International Energy Conservation Code Consensus Committee-Residential

Draft Meeting Agenda (8/16/23 posting)

August 17, 2023
2:00 - 5:00 PM Eastern

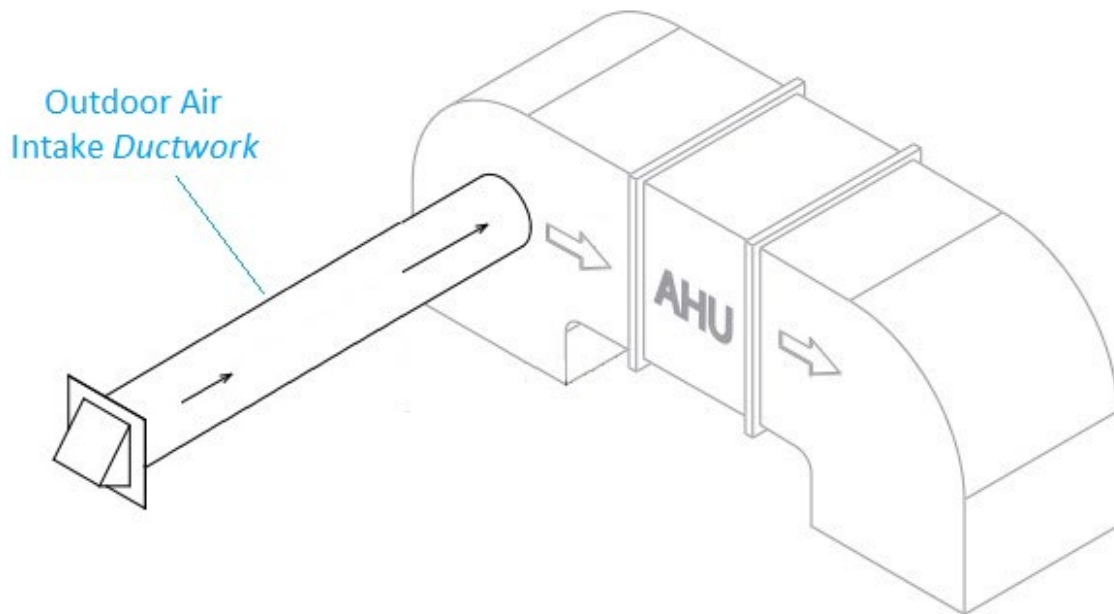
Figure 1: *Ventilation* provided by an outdoor air intake *ductwork* connected to the *ductwork* of a heating or cooling system *air-handling unit*. This is NOT dedicated *ventilation equipment* because it relies on the heating and cooling system’s *air-handling unit* to introduce outdoor air. Note: This proposal would require the outdoor air intake *ductwork* to be insulated where required by the *ventilation equipment manufacturer’s instructions*.

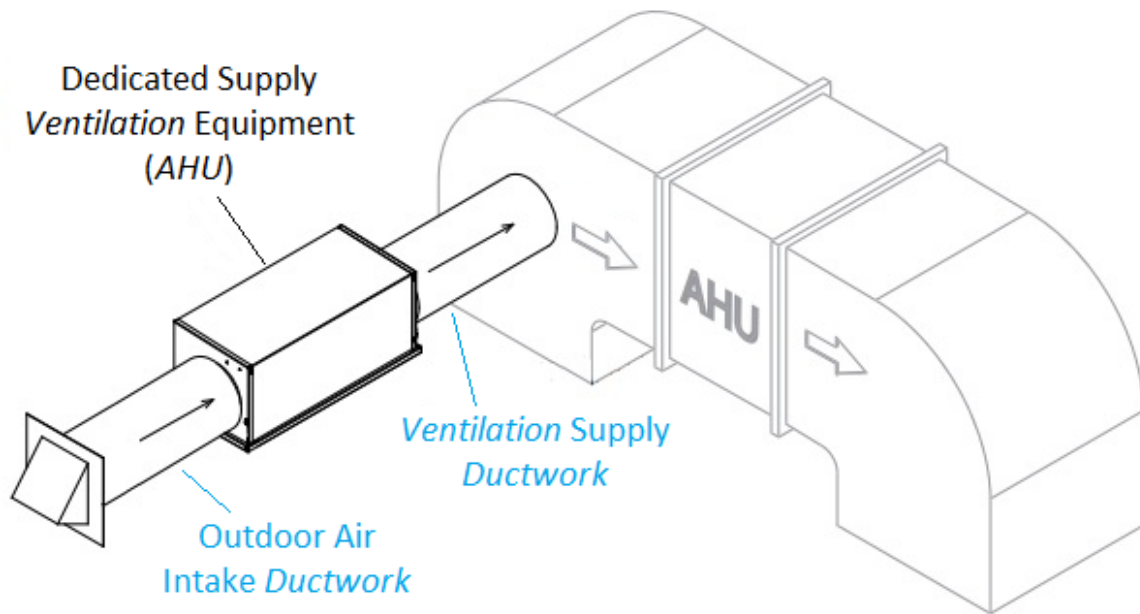
Figure 2a: Ventilation provided by dedicated supply ventilation equipment (i.e., an *air-handling unit*) that is integrated with the heating or cooling system *ductwork*. Note: This proposal would require the supply ventilation equipment's intake *ductwork* and supply *ductwork* to be insulated where required by the supply ventilation equipment manufacturer's instructions.

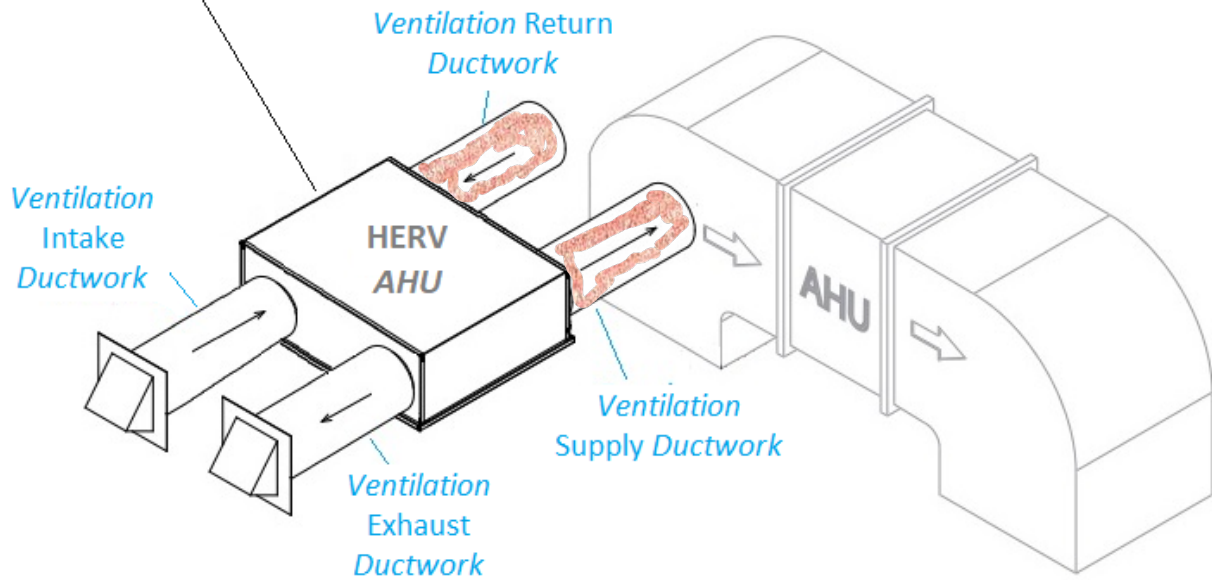
Figure 2b: Ventilation provided by a dedicated HERV's *air-handling unit* that is integrated with the heating or cooling system *ductwork*. This proposal would require HERV return *ductwork* and HERV supply *ductwork* (shown by pink highlights) to be insulated to R-8 where located in unconditioned space. Other *ventilation ductwork* (i.e., outdoor air intake and exhaust) in unconditioned space and *ventilation ductwork* in *conditioned space* must also be insulated where required by the HERV manufacturer's

instructions.

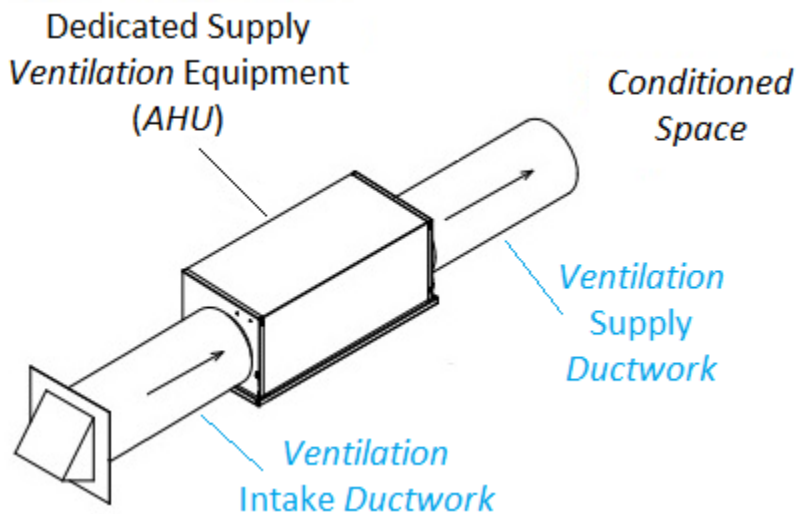
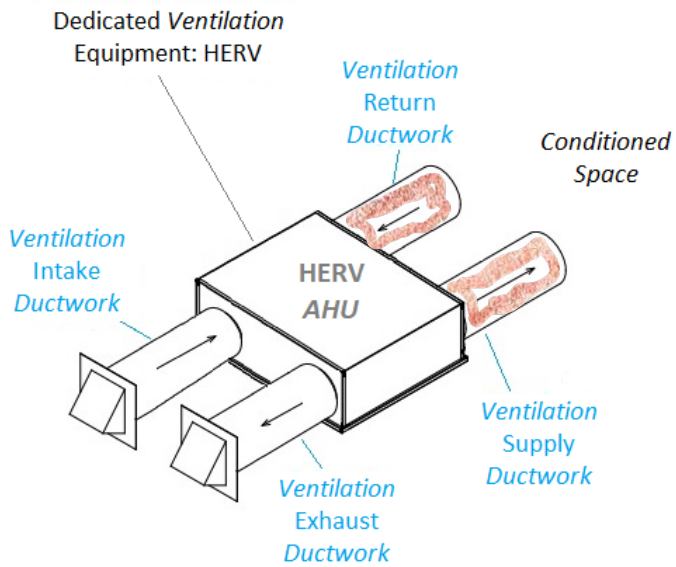
Figure 3a: Ventilation provided by dedicated supply ventilation equipment that is not integrated with the heating or cooling system ductwork. Note: This proposal would require the supply ventilation equipment's intake ductwork and supply ductwork to be insulated where required by the supply ventilation equipment manufacturer's instructions.
